## Appendix IV

### NRC Staff Computational Fluid Dynamics Simulations in Support of the SONGS Audit

The San Onofre Nuclear Generating Station (SONGS) licensee performed computational fluid dynamics (CFD) simulations with the FLOW-3D code that were used as an input to its debris transport analysis [1]. The licensee considered two CFD cases, a large break on the Loop 1 hot leg (Case 1) and a large break on the Loop 2 hot leg (Case 2). The licensee provided FLOW-3D input decks for these two cases for the staff to review during the audit.

**Figure 1: Baseline Case  
Containment Pool Velocity [ft/s]**

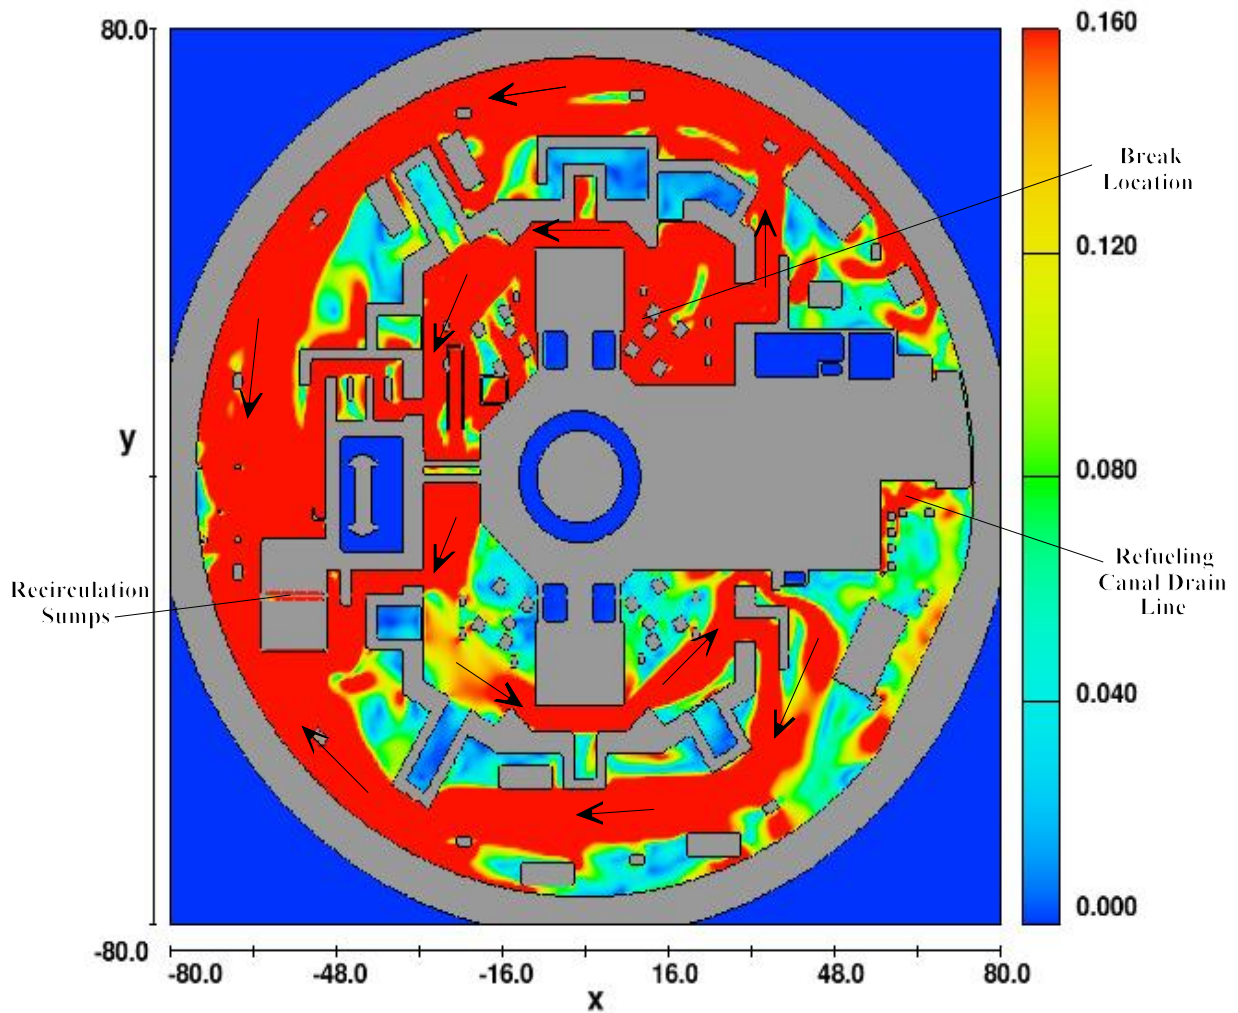
The staff observed that Figure 1 corresponds closely to the analogous figure the licensee generated for Case 1 in the debris transport calculation (Figure 5.9.11) [1]. While this result is expected based upon the fact that no substantial changes were made to the input deck, it confirms that the licensee's results can be essentially replicated on a different computational platform.

**Figure 2: Baseline Case Estimated Mean Kinetic Energy [ft<sup>2</sup>/s<sup>2</sup>]  
Versus Simulation Time [s]**

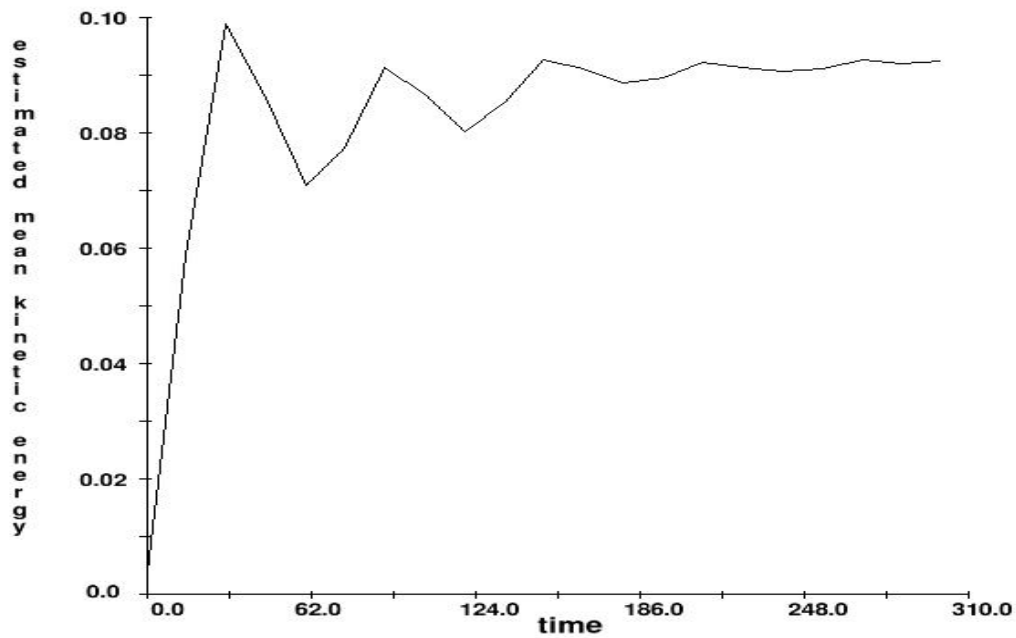
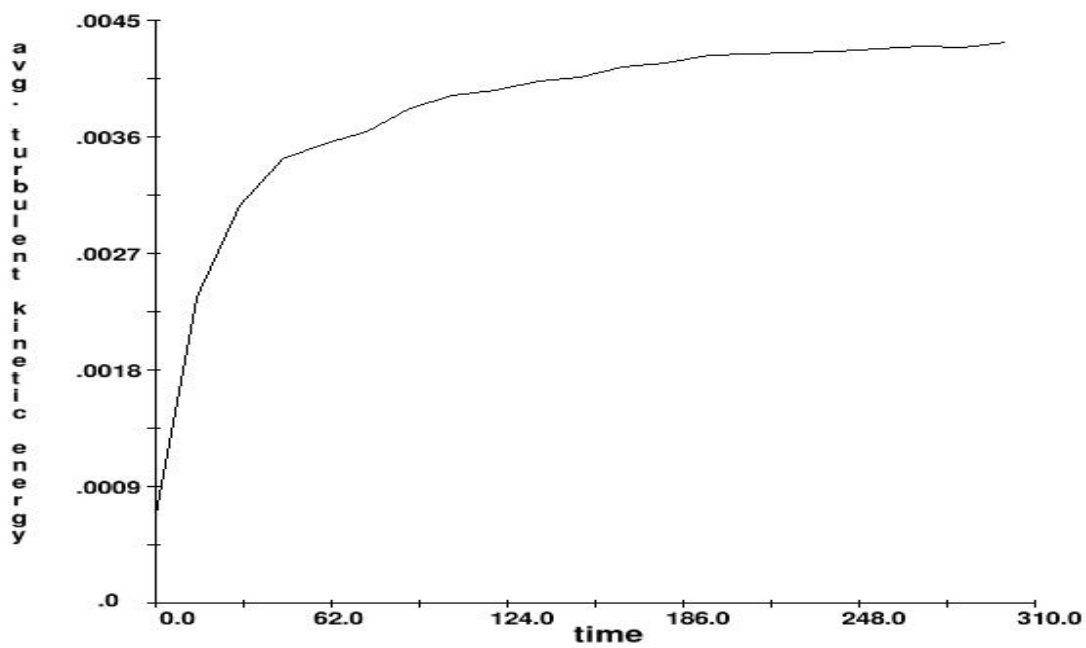
Figures 2 and 3 plot the estimated mean kinetic energy and average turbulent kinetic energy versus time predicted by the FLOW-3D code for the baseline simulation. These plots show that the mean kinetic energy and average turbulent kinetic energy have essentially stabilized by the end of the simulation. The licensee used a mean kinetic energy versus time plot similar to Figure 2 to determine that its CFD simulations had reached a steady state. In discussing Case 1-8, the staff will show that this approach may not be sufficient to ensure that all local flow developments of significance to the overall debris transport results have stabilized.

**Figure 4: Reduced Pool Temperature Case  
Containment Pool Velocity [ft/s]**

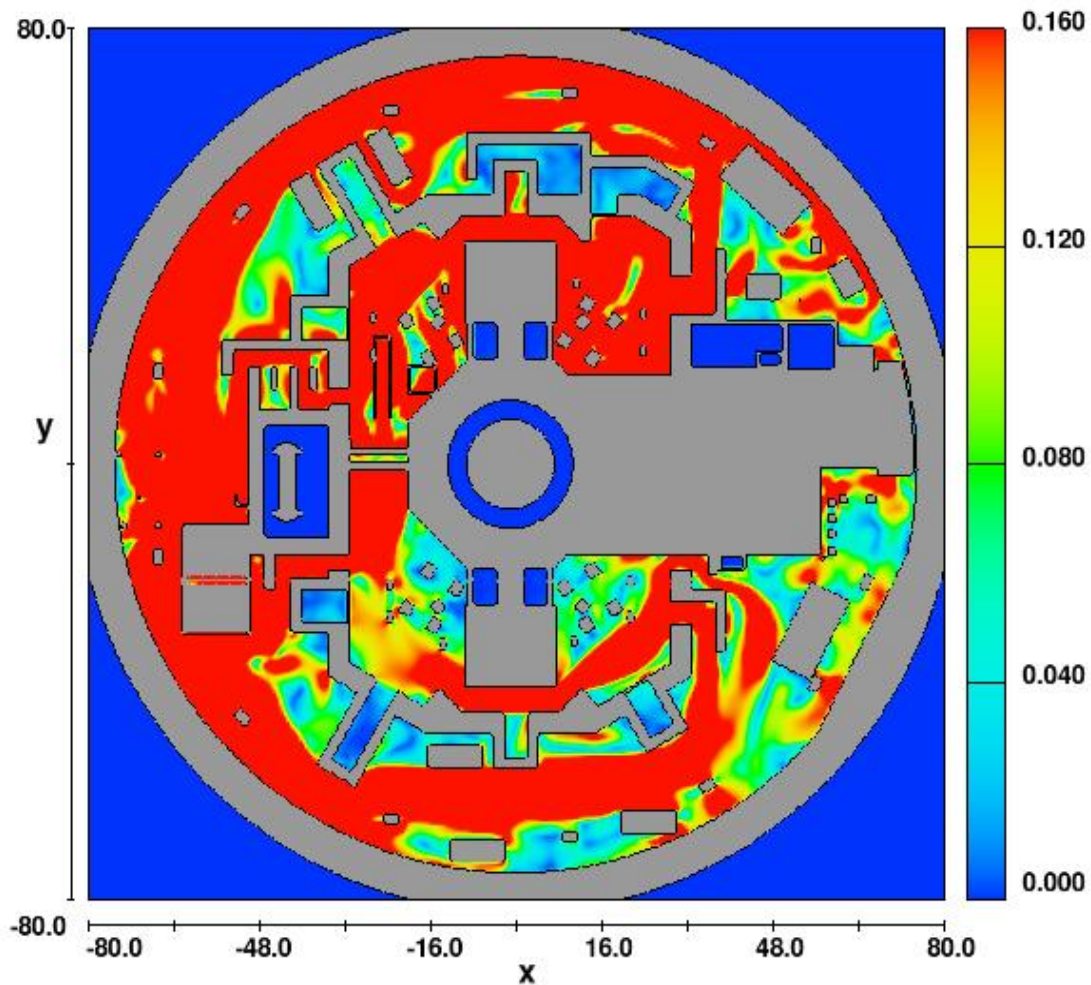
No significant differences were observed from a comparison of the results of the Reduced Temperature Case (Figure 4) to the Baseline Case (Figure 1). The few subtle differences between the two cases may result from fluctuations in the code predictions on the approach to a steady-state solution. The results of the reduced temperature simulation indicate that, barring changes to the physical properties of the debris in the containment pool, the debris transport results are not likely to change significantly as the result of expected changes in fluid temperature and temperature-dependent fluid parameters such as viscosity.

**Figure 5: Southeast Passage Blockage Case  
Containment Pool Velocity [ft/s]**

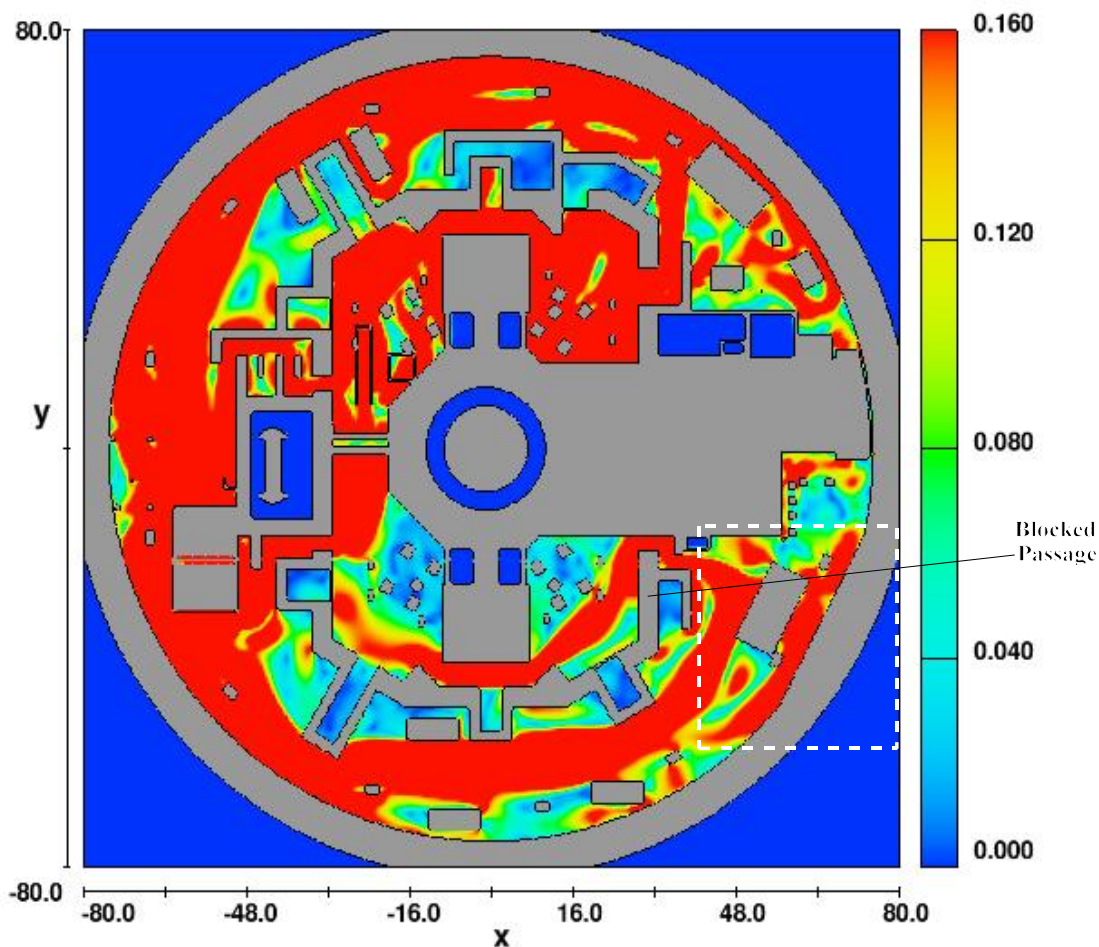
A plot of the resulting velocity magnitude contours after 500 seconds of simulated time is presented as Figure 5. The blocked passage is labeled on Figure 5, which may be compared with the two preceding figures that demonstrate the flow pattern predicted for an unblocked condition.

The results of this sensitivity simulation are generally consistent with the licensee's judgment that explicitly modeling blockage at the lower southeast passage of the Loop 2 compartment would not significantly alter the containment flow field. However, by comparing the flow velocities in the southeast quadrant (i.e., lower right corner) as well as other areas of Figures 1 and 5, local perturbations are obvious. A dashed-line box is provided on Figure 5 to emphasize the most obviously perturbed local area. Other changes are also apparent, some of which were likely due to the additional 200 seconds of run time as compared to the baseline case, and which will be addressed subsequently as part of the Case 1-8 discussion.

Based upon SONGS-specific characteristics, including the geometric layout of the containment and analytical assumptions such as the assumed spatial distribution of debris at the initiation of sump recirculation (refer to Section 3.5.3.1 of the main report), the staff concluded that the containment pool flow field perturbations associated with this sensitivity case are not sufficient to impact the overall debris transport results for the Case 1 break. The staff further considered the potential for blockage at this passageway for Case 2 break conditions, as described subsequently in the discussion of Case 2-2 and Case 2-3.

**Figure 6: Elimination of Containment Spray Alternating Horizontal Velocity Component Case, Containment Pool Velocity [ft/s]**

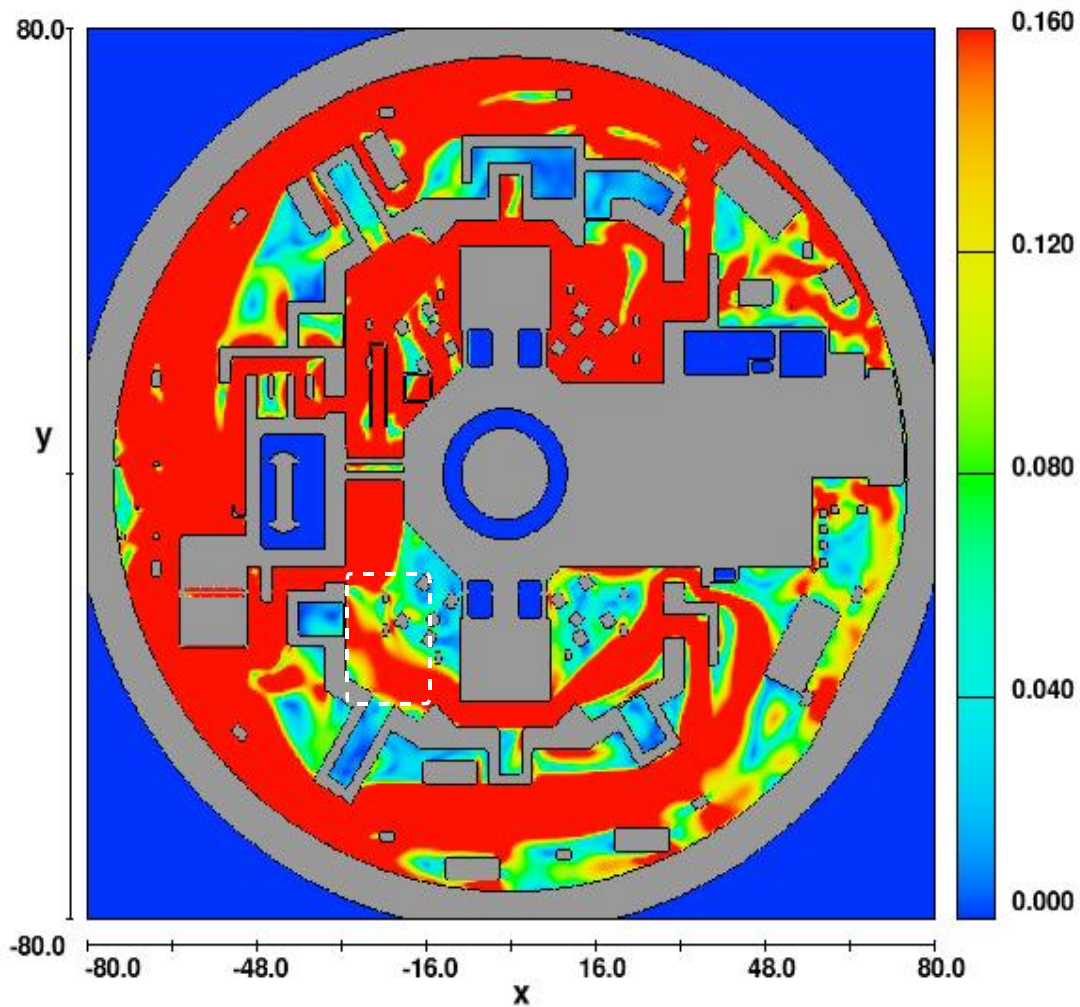
A comparison of Figures 1 and 6 reveals only minor differences. The most significant of these minor differences appear to be attributable to differences in the simulation time (i.e., Figure 1 is based on a 300-second run and Figure 6 is based on a 500-second run) rather than the elimination of the horizontal component of the spray vector (which can be appreciated subsequently in the discussion of Extended Simulation Time Case, Case 1-8). One such difference is enclosed by the dashed-line box on Figure 6. The staff's comparison of Figure 1 and the Case 1-4 simulation results at 300 seconds (plot not included in this appendix) show that velocity predictions for the area within the dashed-line box are essentially equivalent. The effects of extending the simulation time will be examined in more detail in the discussion of Case 1-8.

In addition, the staff notes that the predicted flow field in the locations where containment spray is introduced to the model, particularly the regions near the containment wall on the west and south (i.e., left and bottom) of the containment pool, does not appear to be significantly affected by the removal of the horizontal velocity component (the containment spray flow addition locations for the CFD model are summarized in Section 3.5.4.1 of the main report). Based upon the assumptions made by the licensee for the spatial distribution of debris at the initiation of sump recirculation (refer to Section 3.5.3.1 of the main report), the staff concluded that the minor differences observed between Figures 1 and 6 would not appreciably impact the overall transport results.

**Figure 7: Increased Containment Spray Flow Case  
Containment Pool Velocity [ft/s]**

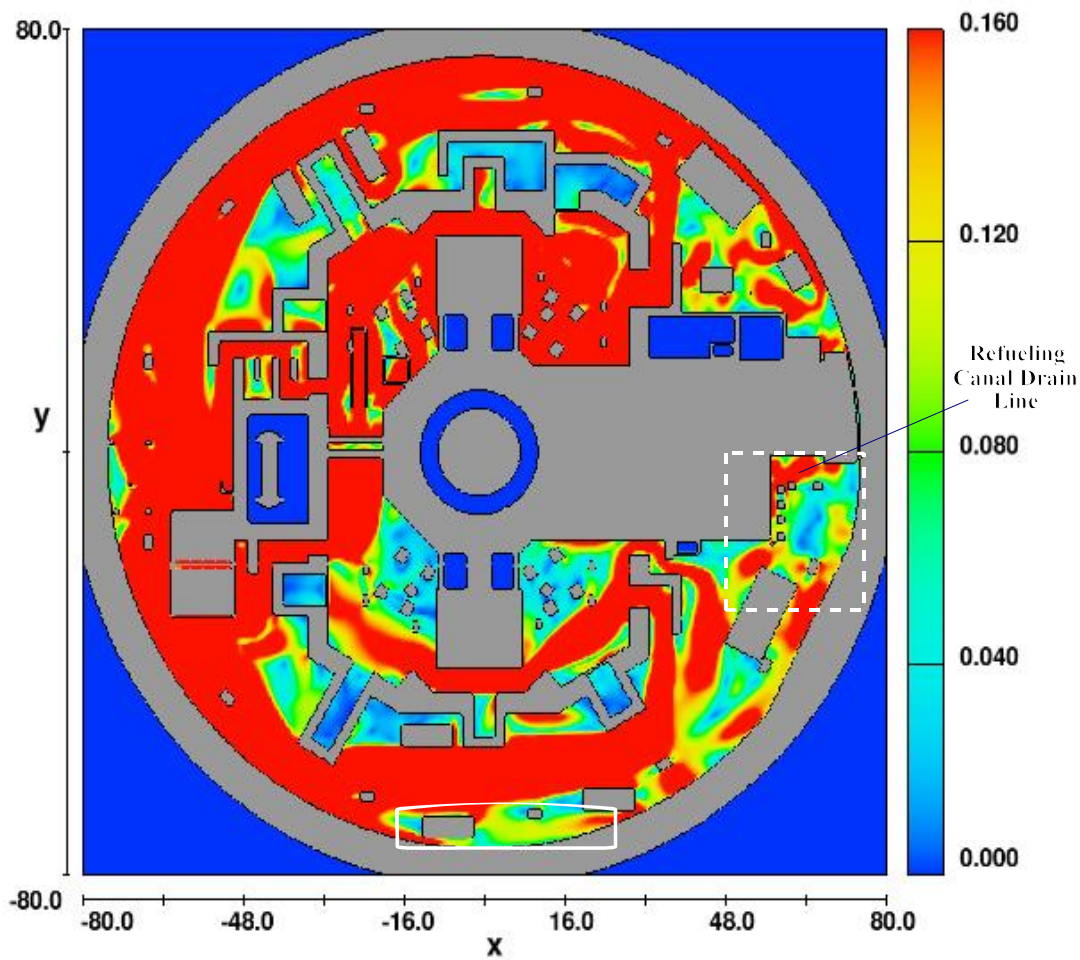
As may be observed from a comparison of Figures 1 and 7, the 20% increase in total containment spray flow does not have a significant impact on the overall containment flow pattern. However, slight increases in velocity magnitude are visually apparent in several areas.

In particular, the staff focused upon one of these areas in the upper southeast quadrant of the containment pool, which is enclosed inside a dashed-line box on Figure 7.

Velocity increases within the dashed-line box on Figure 7 are of potential significance because the refueling canal drain line is located within the red-shaded area near the upper center of this box. As noted in Section 3.5.1 of the main report, 22% of washed-down debris is modeled as entering the containment pool through the refueling canal drain line. For the baseline case simulation depicted in Figure 1, it can be inferred that any small pieces of debris entering the containment pool via the refueling canal drain line would tend to settle because the velocities in this region do not exceed 0.16 ft/s (refer to the discussion of transport metrics in Section 3.5.3.2 of the main report). However, Figure 7 shows that, when the total containment spray flow is increased by 20%, the licensee's metric for tumbling transport of small pieces of mineral wool (i.e., 0.16 ft/s) is approached in the vicinity of the refueling canal drain line, although it does not appear to be exceeded along a continuous path to the recirculation sumps.

Considering the velocity increases computed for this sensitivity case, the staff decided to investigate further whether small pieces of mineral wool debris washed down through the refueling canal drain line (i.e., a total quantity of approximately 10 ft<sup>3</sup>) that the licensee's calculation considers non-transportable could actually reach the sump strainers given a credible perturbation to the spray drainage pattern. Since a 20% increase in total containment spray flow may not be credible for SONGS, the subsequent staff sensitivity simulation examines transport from the refueling canal drain area for the more credible scenario of changing the spatial distribution of the containment spray drainage flow, but maintaining the total flow rate at its baseline value.

A solid-line box is also depicted on Figure 7, which highlights an area near the south wall of the containment wherein small pieces of mineral wool debris would generally not have sufficient velocity to reach the recirculation sumps. This area is highlighted because a significant quantity of containment spray drainage and entrained washed down debris are assumed to enter the containment pool within this area, as well as the region immediately surrounding the box (refer to Sections 3.5.3.1 and 3.5.4.1 of the main report). Although the simulated increase in spray flow slightly reduced the size of the enclosed low-velocity area, due to the presence of several flow obstacles the flow field changes in this area are not sufficient to significantly affect the overall debris transport results.

**Figure 8: Increased Refueling Canal Drainage Flow Case Containment Pool Flow Velocity [ft/s]**

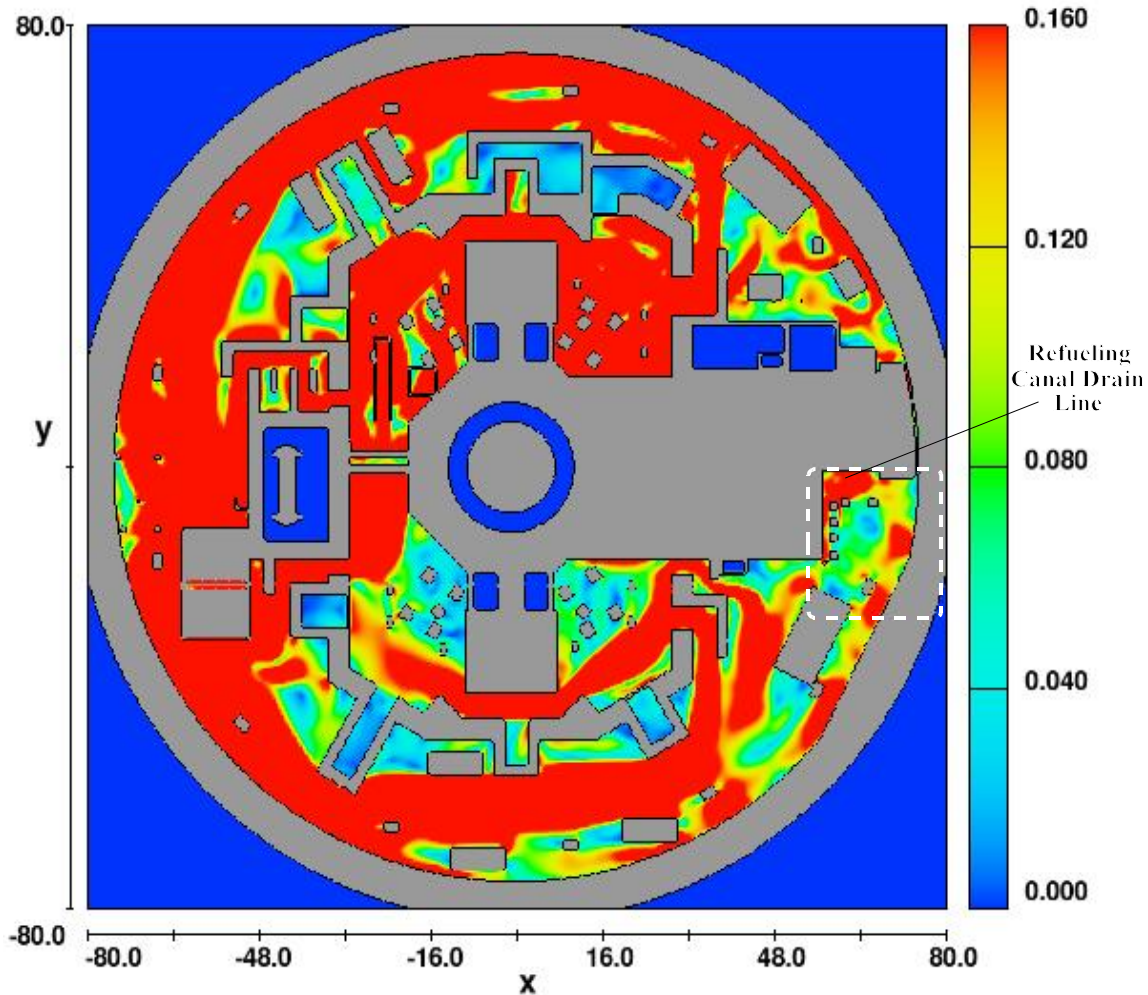
As expected from the results of the previous case, the overall containment flow pattern is not significantly affected by the increased refueling canal drainage flow. However, similarly to the previous results shown in Figure 7, increased local velocities are noted in Figure 8 inside the boxed area in the vicinity of the refueling canal drain line. These local velocities appear to be closely approaching the 0.16-ft/s metric at which the licensee assumed that small pieces of mineral wool can transport along the containment floor by tumbling. However, it is noted that, once again, the assumed transport metric is not exceeded along a continuous path from the refueling canal drain line to the recirculation sumps.
